**ARCHITECT'S SUPPLEMENTAL INSTRUCTIONS**

PROJECT: Lee Lofts III  
Historic Rehabilitation & New Apartments  
Salina, KS Report No. Two (2)

CONTRACTOR: MCP Group  
3501 SW Fairlawn Rd.  
Topeka, KS 66614 Architect's Proj No. 22-3243

DESCRIPTION:

**3RD LEVEL (4TH, 5TH SIM.) FLOOR PLAN**  
 1/4"=1'-0" 6,856 sf

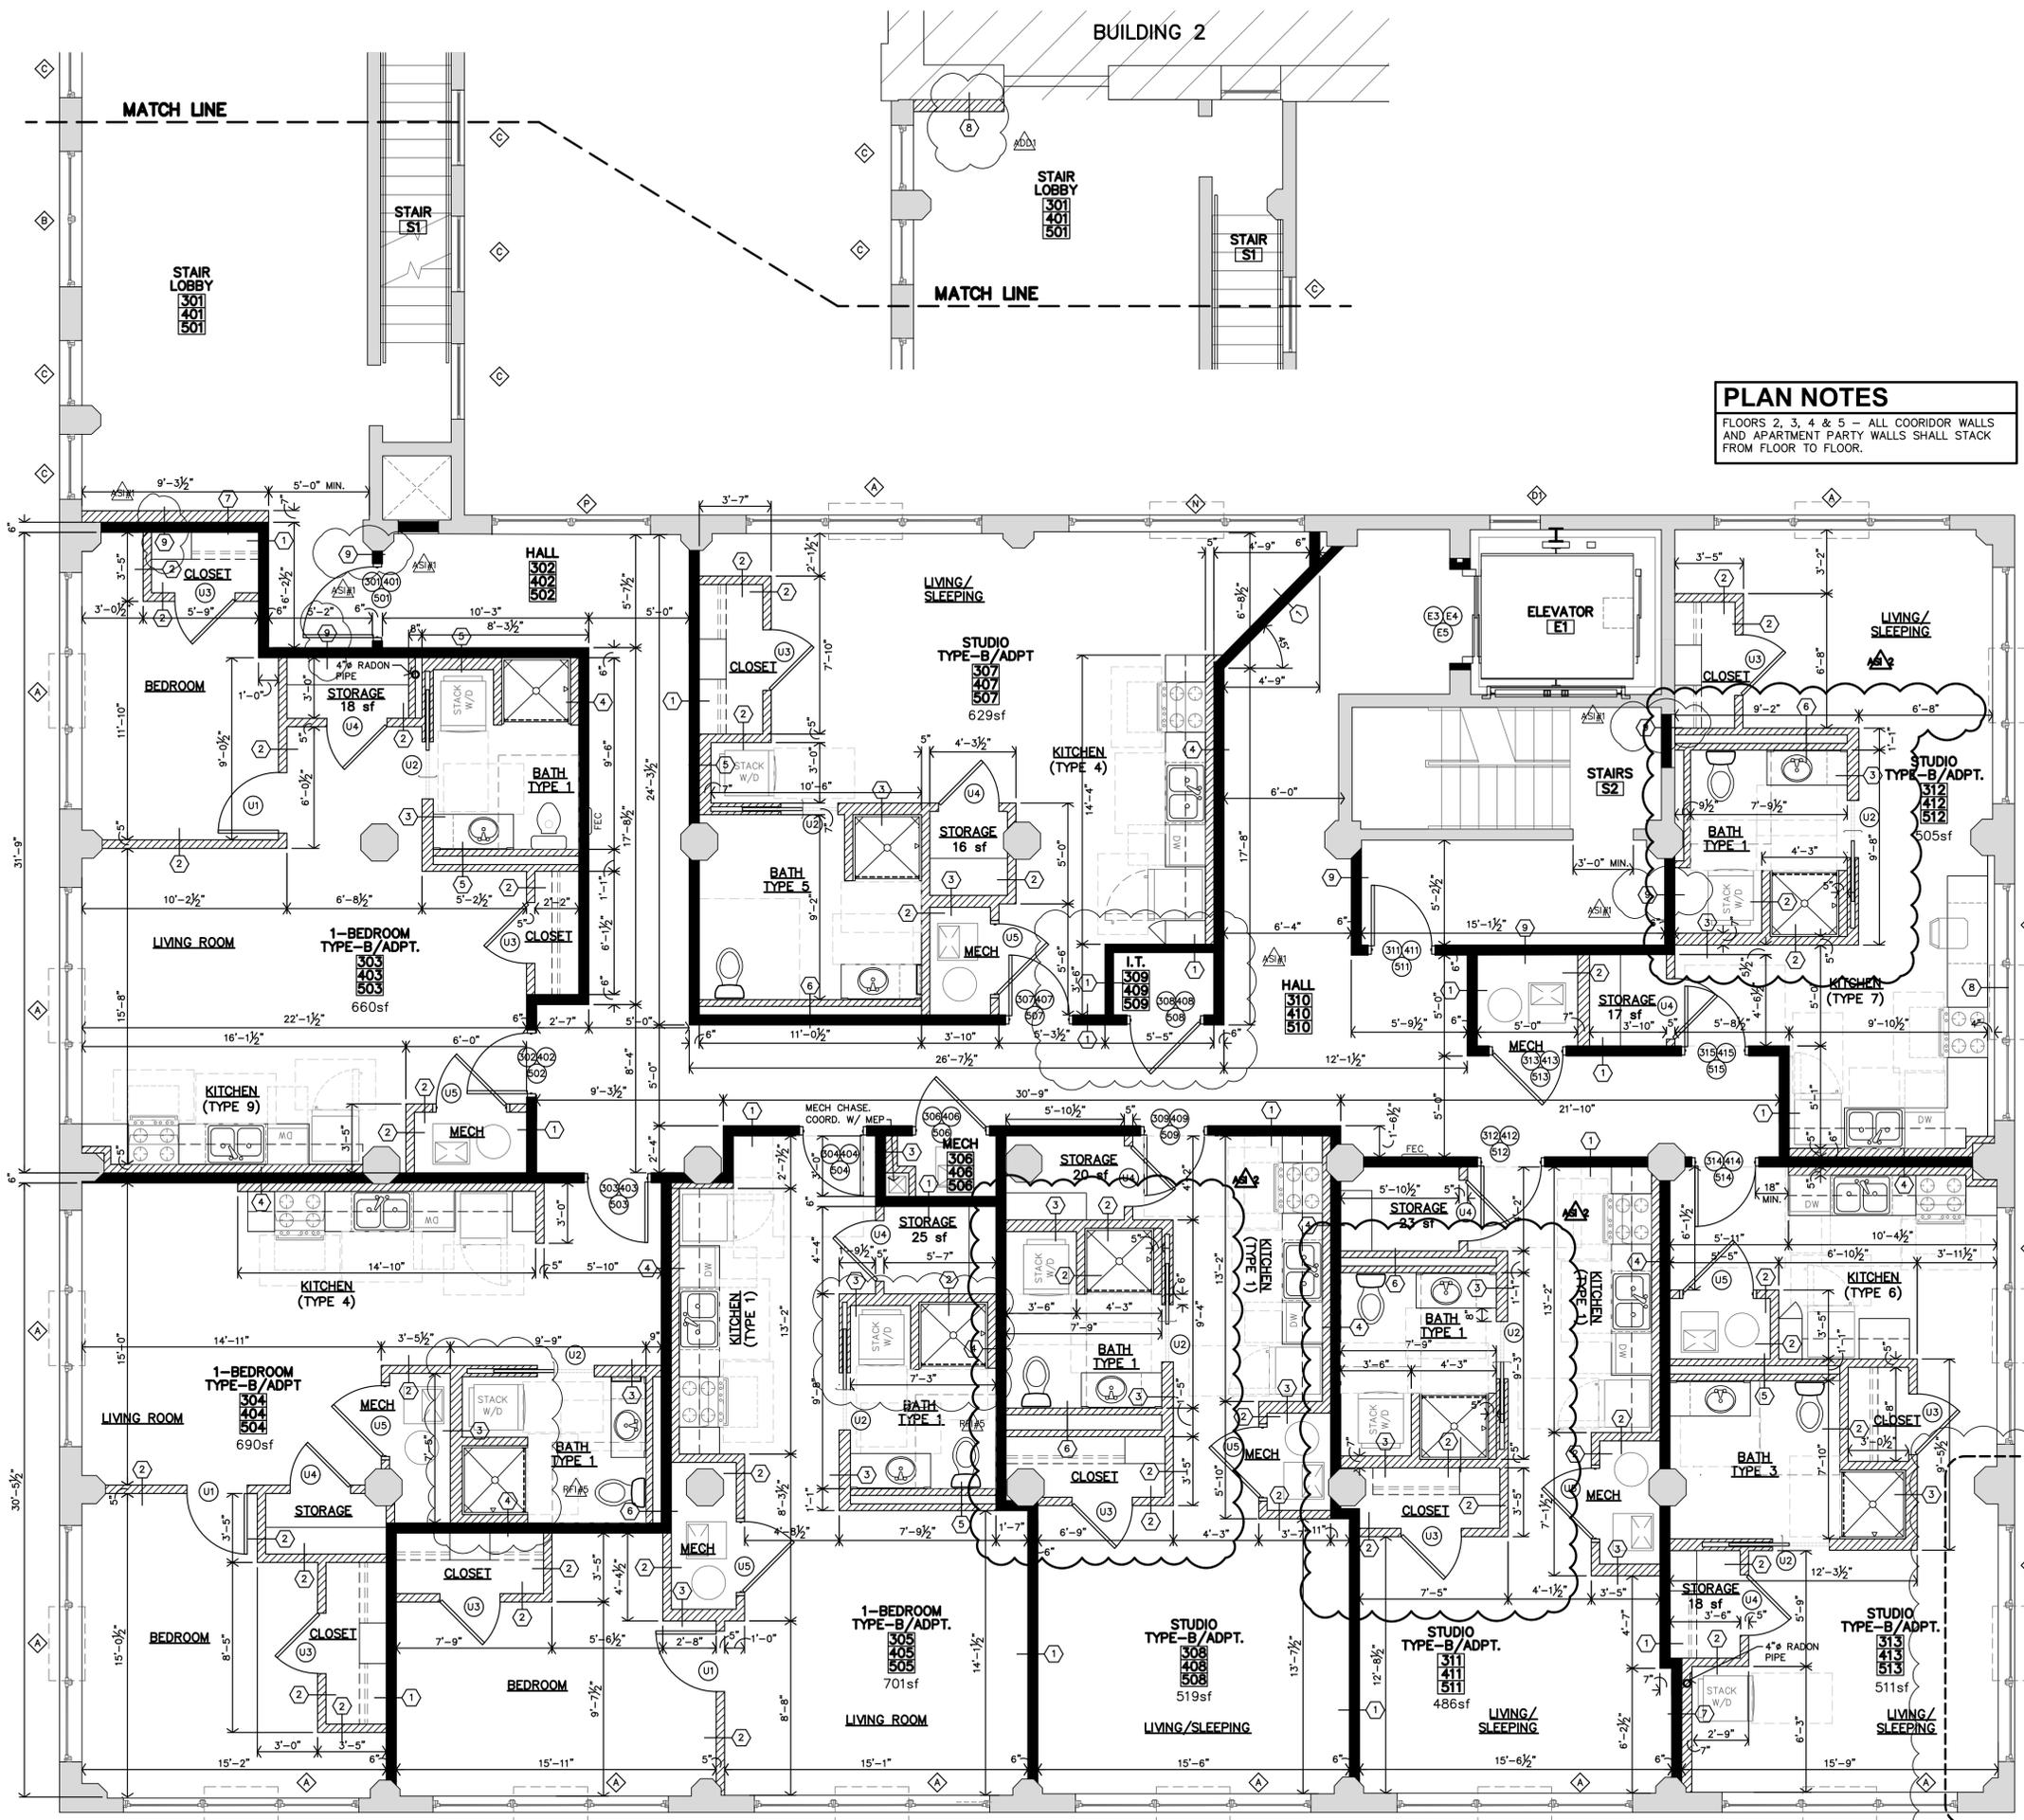
- a. Unit 105 – Mirrored Laundry and Shower. Added furred wall next to pocket door for plumbing
  - b. Units 208, 308, 408, 508 – Mirrored laundry and shower. Added furred wall next to pocket door for plumbing. Widened entire bath (and closet below) by 6". Shifted toilet and vanity wall north by 4"

- c. Units 211, 311, 411 & 511 – Mirrored entire bathroom and plumbing chase, so toilet and vanity are on north end. Mirrored Laundry and shower. Added furred wall next to pocket door for plumbing. Widened entire bath (and closet below) by 6"

- d. Units 212, 312, 412 & 512 – mirrored laundry and shower. Added furred wall next to pocket door for plumbing. Widened entire bath (and closet below) by 6"

**1 SECOND FLOOR HVAC PLAN**  
 3/16" = 1'-0"

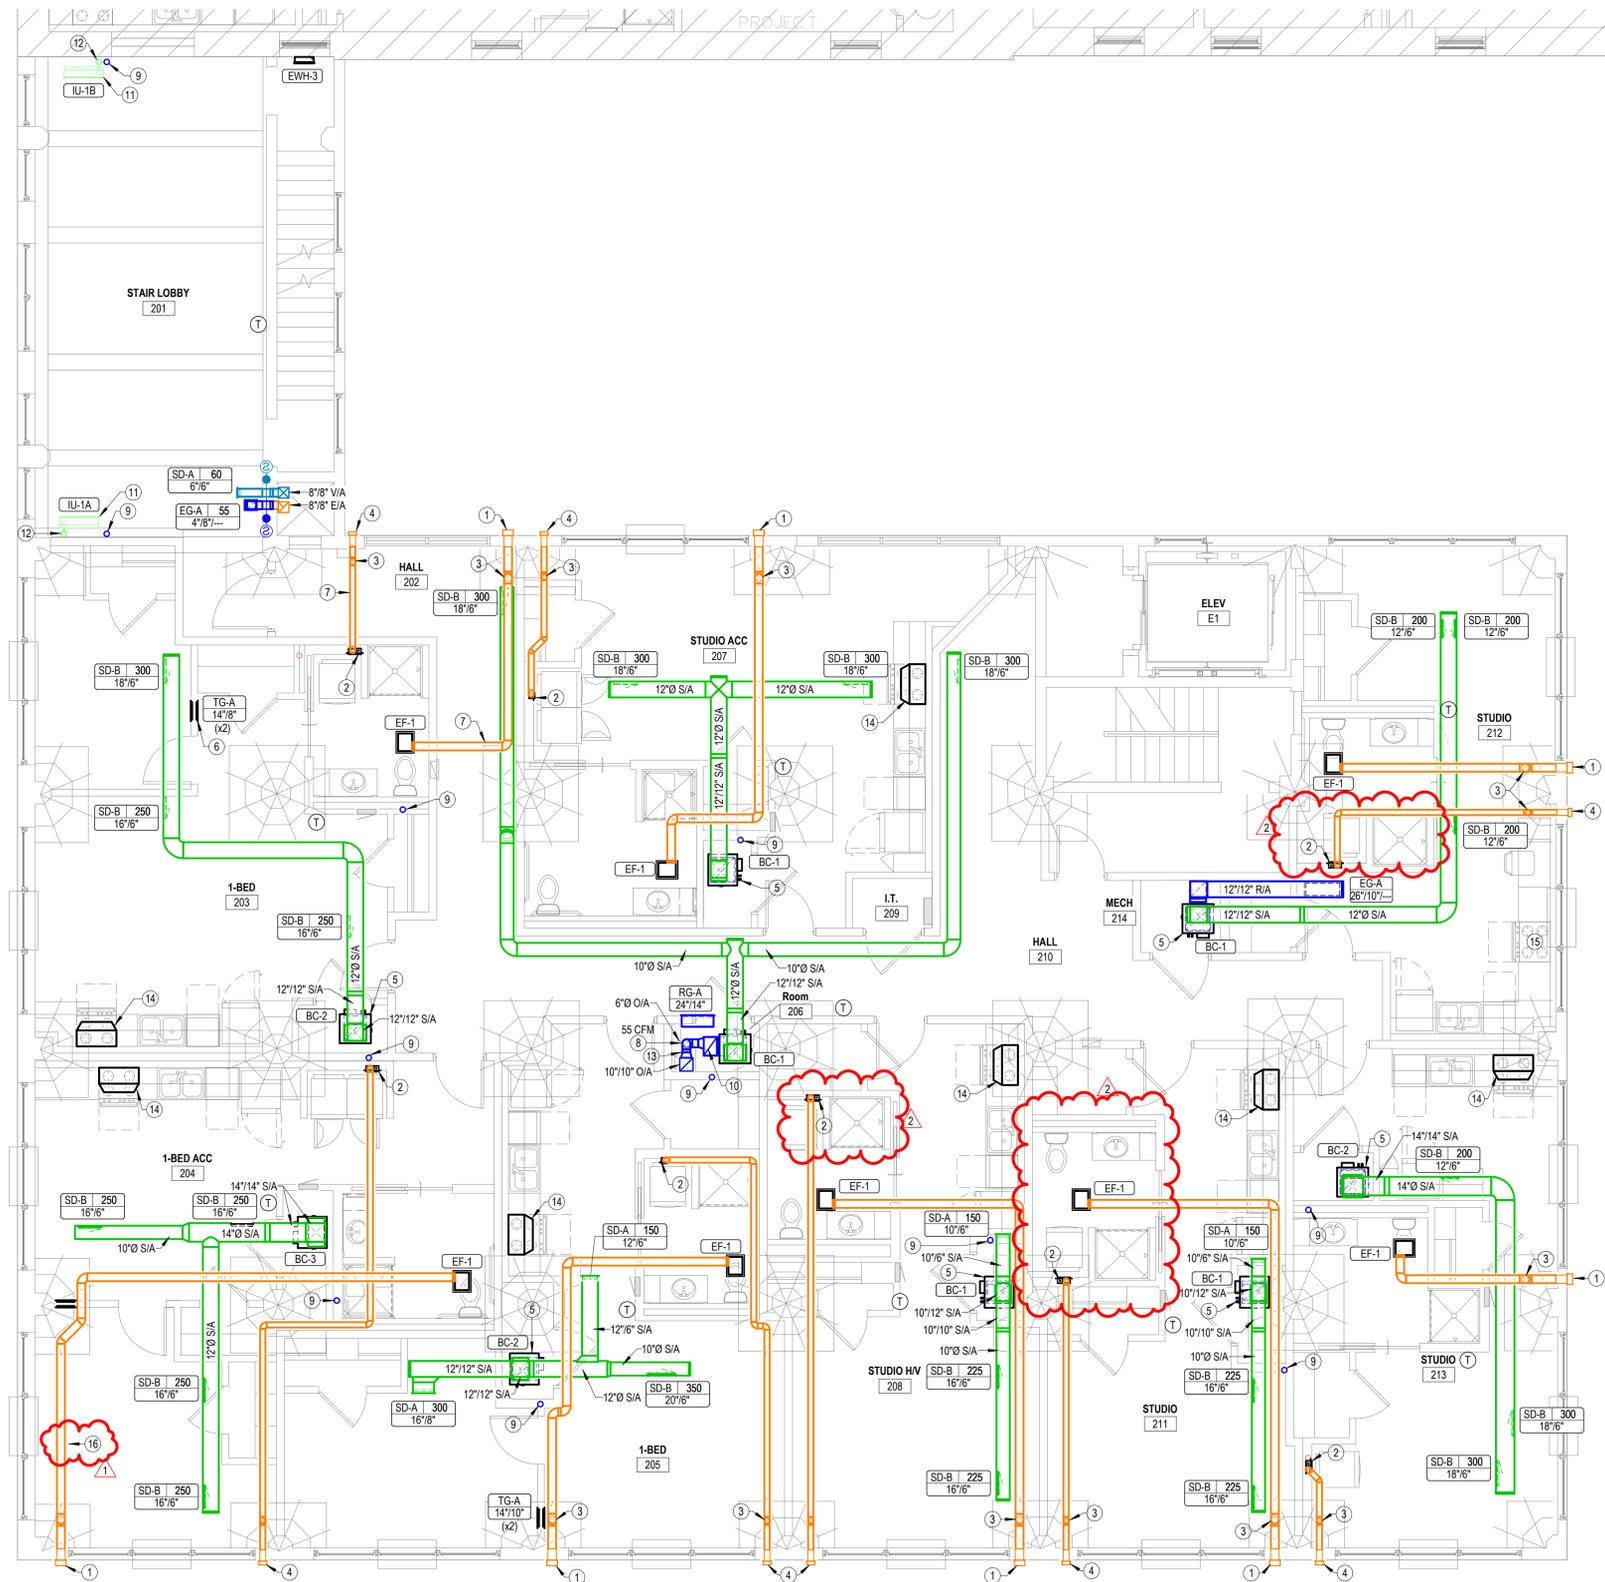
- e. MEP – Plumbing, Electrical and dryer exhaust modified to accommodate new layouts in restrooms in Units 105, 108, 111, 208, 211, 212, 308, 312, 408, 411, 412, 508, 511, and 512.
